Procurement of Plant for Design, Supply, Installation and Commissioning of Gas insulated 220kV Lapsipedi Substation, 132kV Changunarayan Substation and upgradation of Teku Substation and Suichatar Substation.				
ICB: PMD/PTDEEP/LCSCP-073/74RE-01				
CLARIFICATION 1 ISSUED BY NEPAL ELECTRICITY AUTHORITY				
SI N	Reference Section & Clause	Description	Bidder's Query/ Changes suggested	Client Response
General & Commercial				
1	SECTION 1- ITB CLAUSE NO 21	Bid Security	we presume that the BG against Bid security issued by an Indian bank is accepted to NEA and it is not required to have counter guaranteed by a commercial bank in Nepal? Please confirm.	Confirm
3	Vol-II	MV & EHV Cable Specification & Control and Power Cable	GTP and Technical Specification is not available for 72kV, 145kV and MV Cables and LT (power and control) Cables. Please provide the same.	Please Refer GTR, Chapter 22 - EHV XLPE and GTR, Chapter 9 - Power and Control Cable

CLARIFICATION 1 ISSUED BY NEPAL ELECTRICITY AUTHORITY				
SI N	Reference Section & Clause	Description	Bidder's Query/ Changes suggested	Client Response
		However, IF the Bidder/Manufacturer has not conducted the complete type tests including DSC i

RELEASED FOR TENDER PURPOSE ONLY

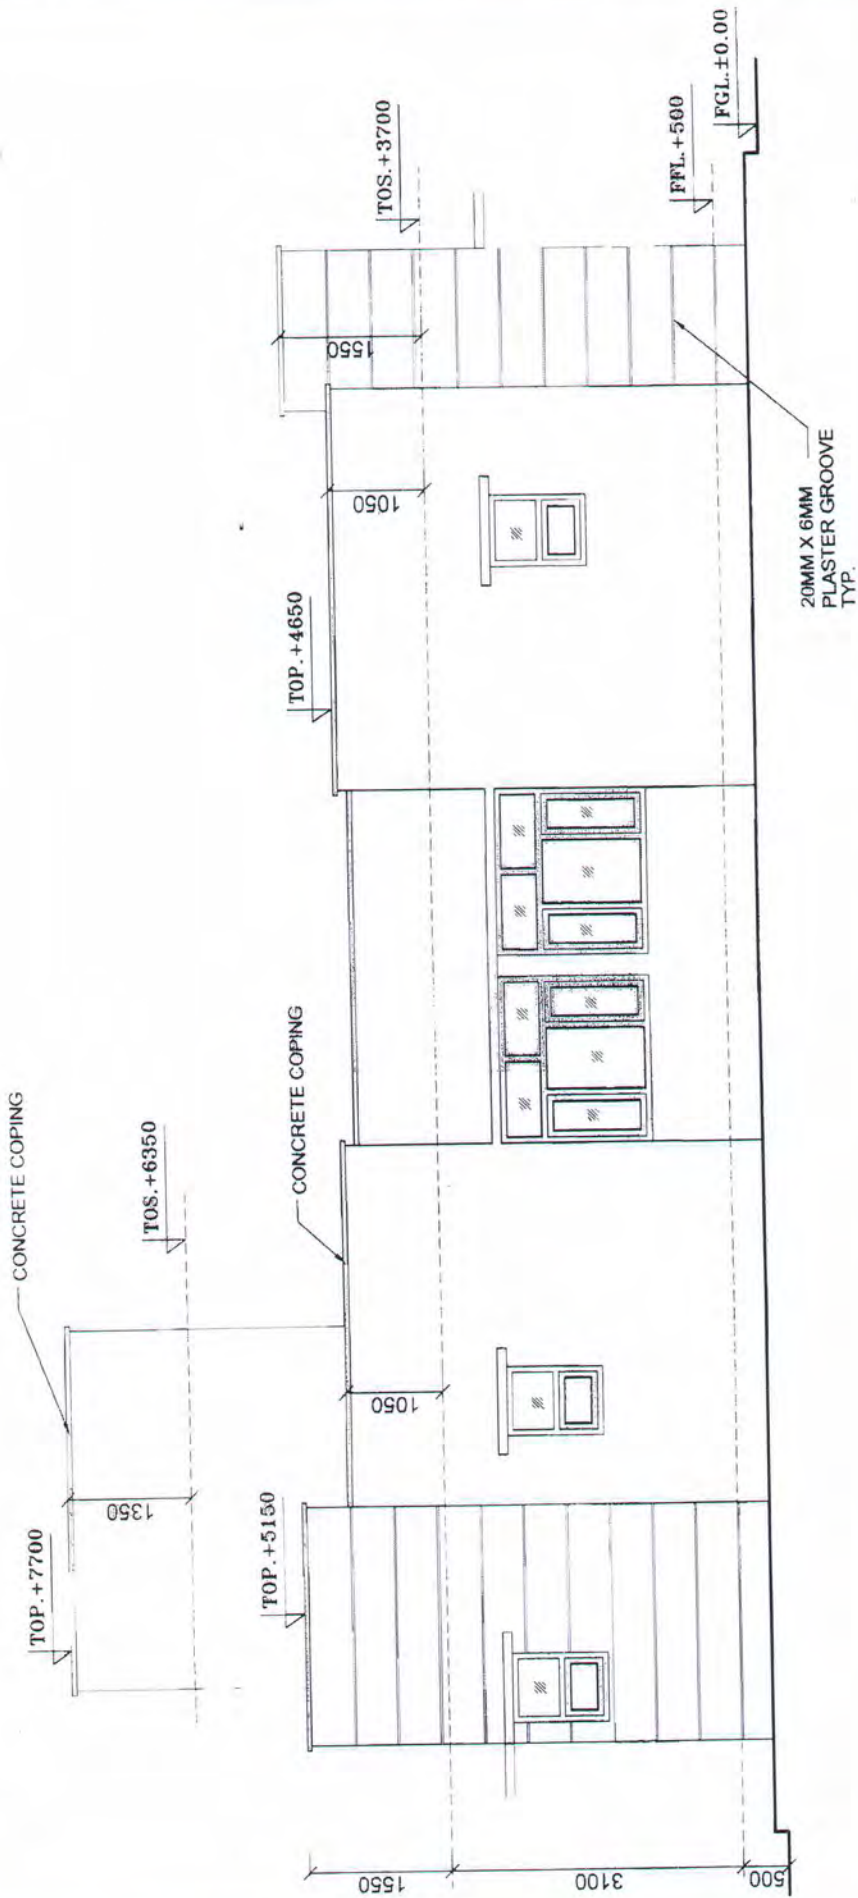
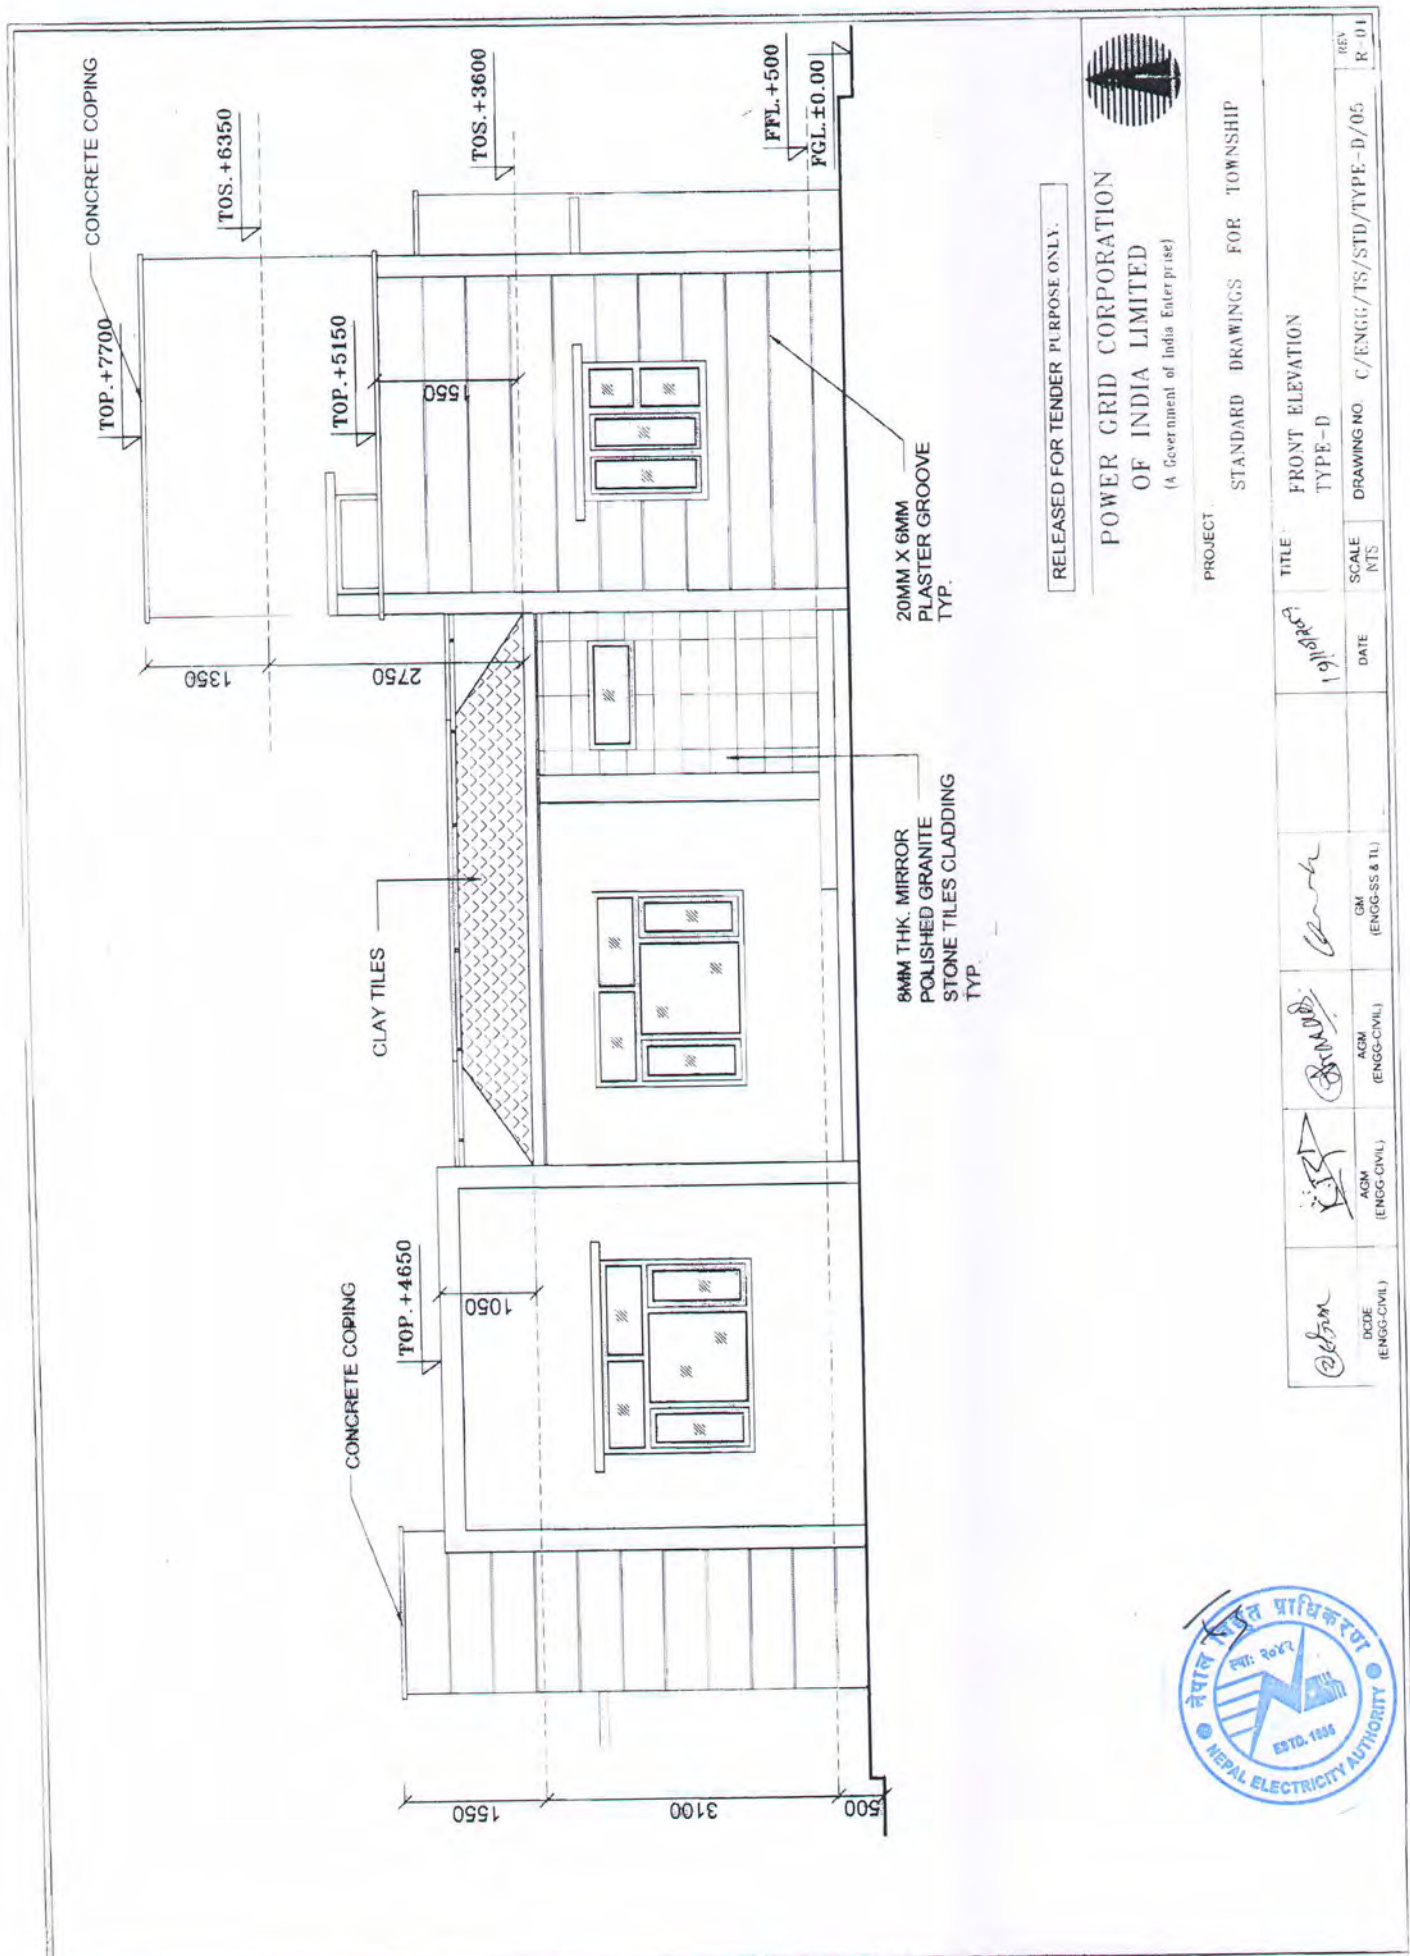
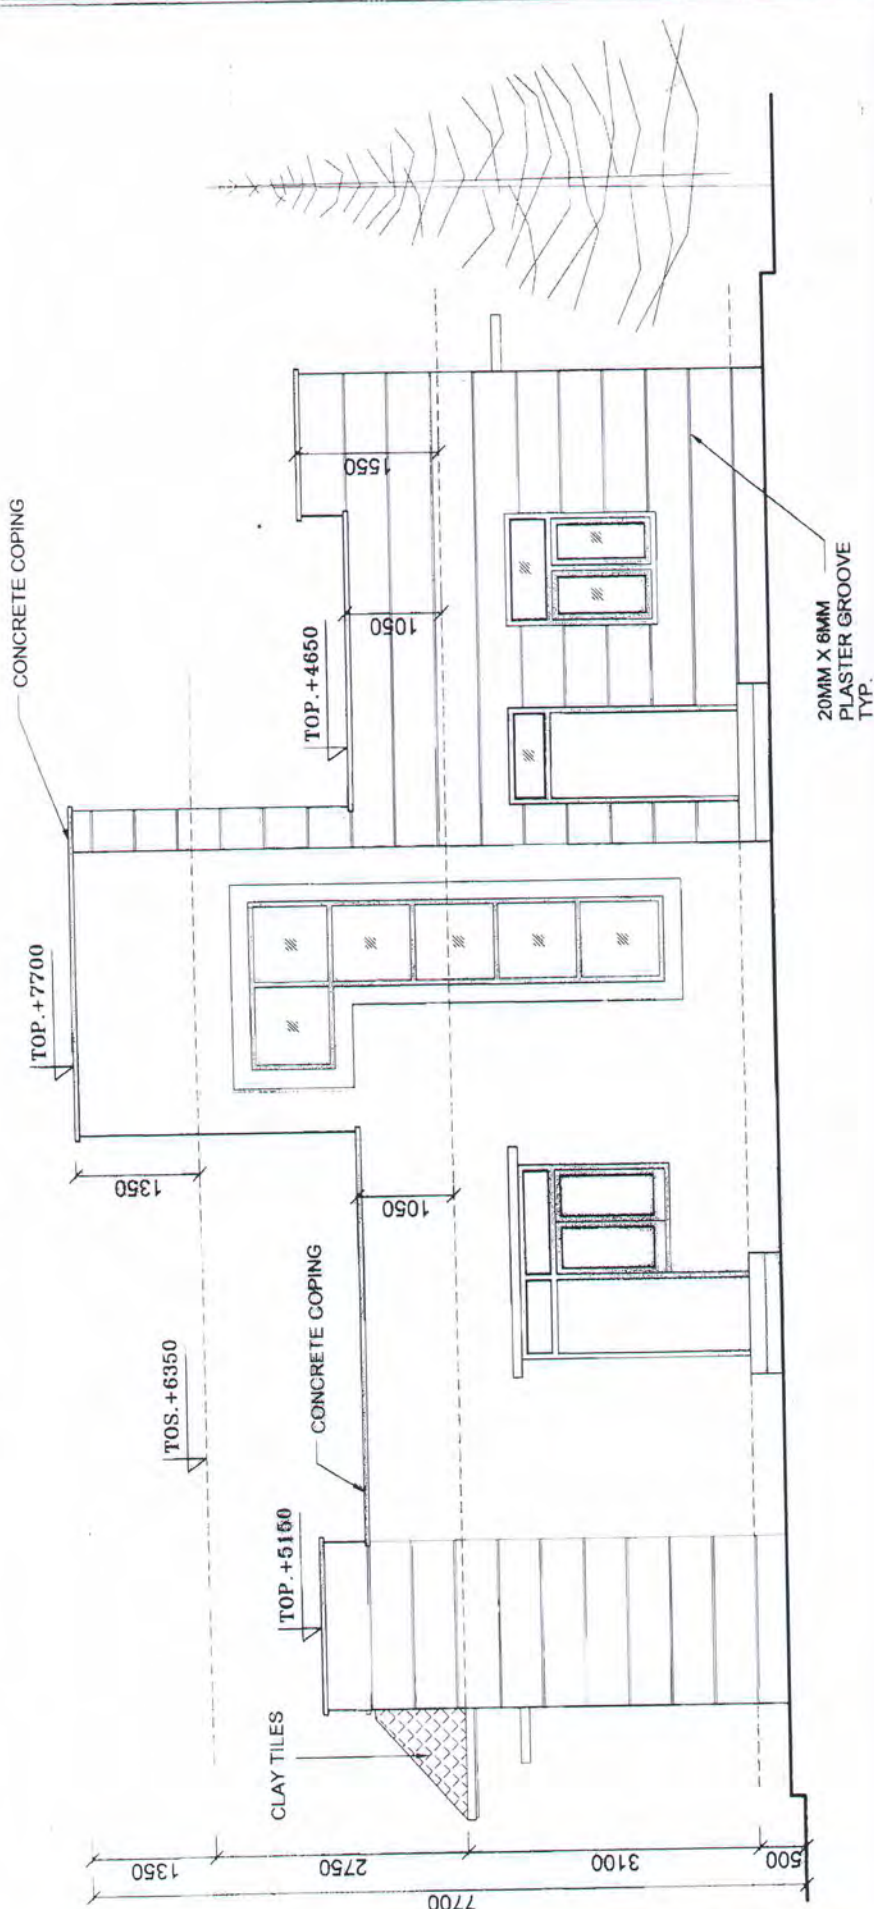
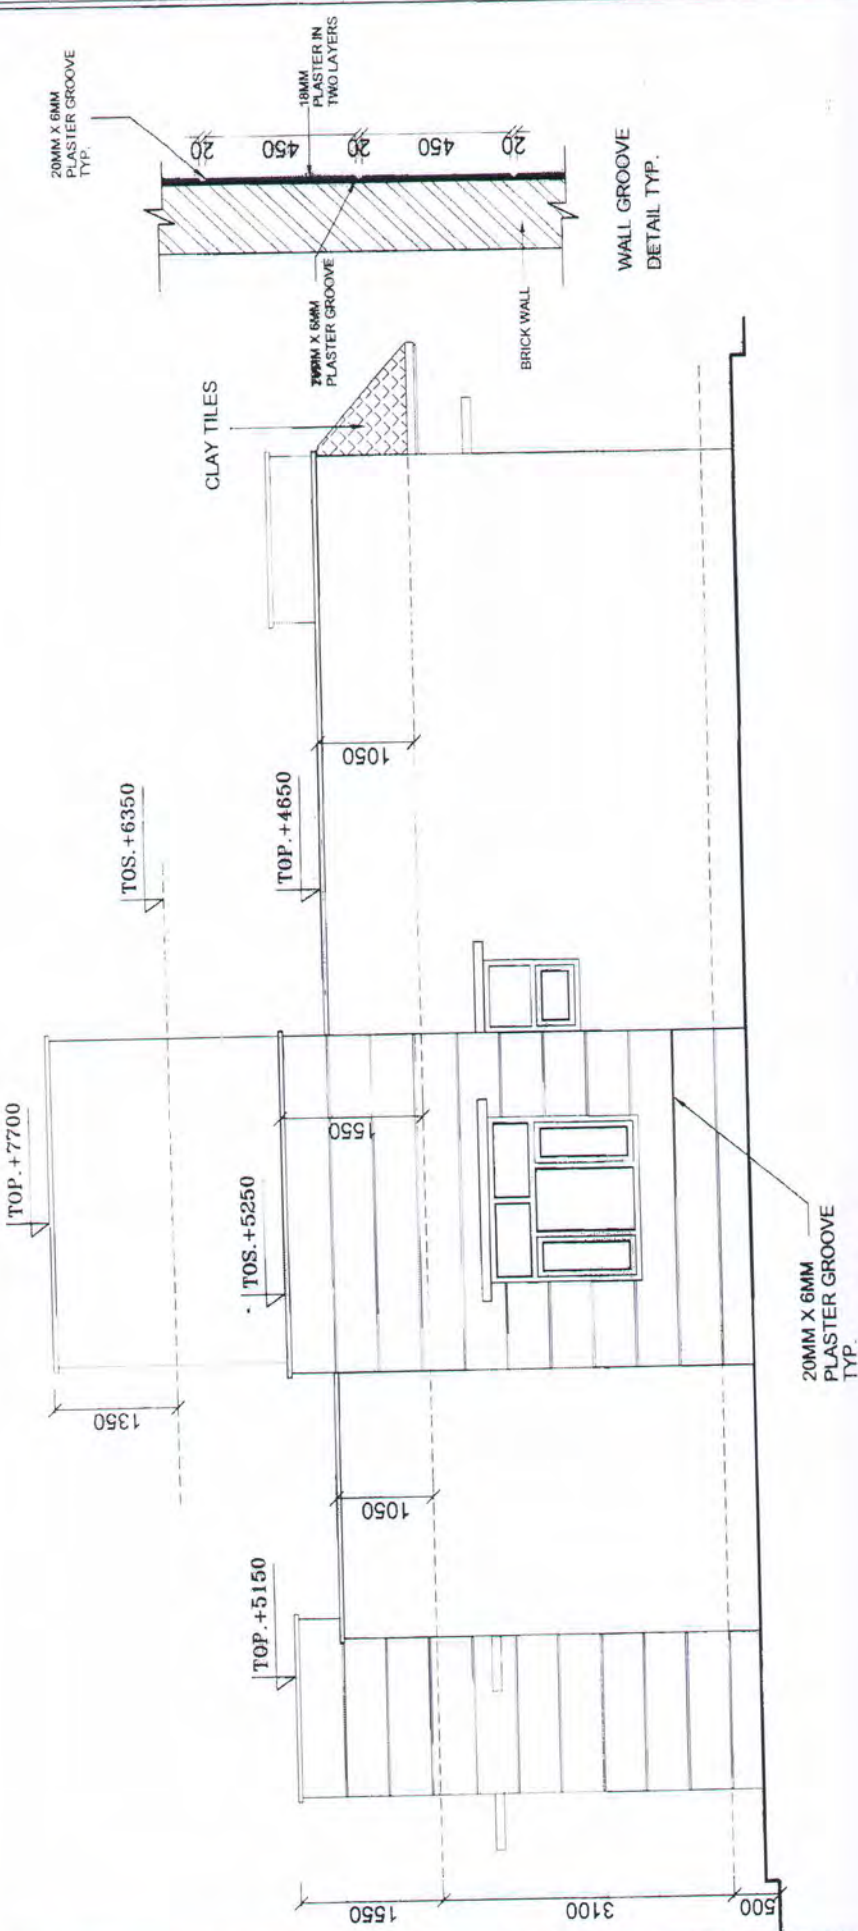
166	Volume II, CH-1 (Project Specification Requirement)	Clause no- 4.1.28 ( C)	As per referred clause , the Quarters buildings (B,C,D type) are in bidders scope. Please provide the following drawings to estimate the finishes quantity of the buildings.  1. Building Plan with room dimension. 2. Elevation of drawing. 3. Section details.	Please find the attached drawings.
167	Volume II, CH-1 (Project Specification Requirement)	Cl.no : 6.1 e	As per referred clause, seismic requirement for proposed substation is 0.5g which is very Severe and much higher than the maximum critical value in IS:1893. We have considered that, bidders shall do civil & Structural design. Please confirm.	Confirm
168	Volume II, CH-1 (Project Specification Requirement)	Clause no- 4.1.28 ( C) & 4.3.3	We presume that the pile foundation, Rubble soling or any additional foundation protection works is not envisaged for the proposed Lapsephedi & Teku Substation. If required the same shall be paid in additional item with mutually agreed rate. Please confirm.	If pile foundation is required at Lapsephedi, Suichatar or Teku Substation, the rate of Chanunaryan BPS will be considered. The existing GIS cum control building at Teku is on normal foundation.
